NUMBER: B406R1139-0 DATE: SEPT. 3, 1993

SERVICE BULLETIN

Ride: CENTURY WHEEL

Subject: FENCE REWORK

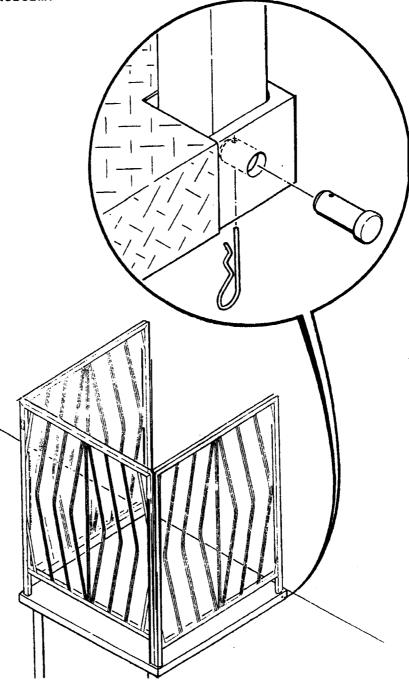
Chance Rides, Inc. has become aware that on the CENTURY WHEEL it is possible for the side fences around the operator's pedestal to slide up and down in the connecting sockets if the operator leans against the back fence section. If the side fences were to come all of the way out of the connecting sockets, injury to the operator and/or damage to the fences could result.

- Install fences around operator's platform, making sure fences are properly seated in connecting sockets.
- Centered in socket area, drill a 1/4 inch diameter hole (two places, opposite sides of platform) through side of platform and one side of the fence tube.
- 3. Insert clevis pin from outside and secure in place with R-key from underneath platform.
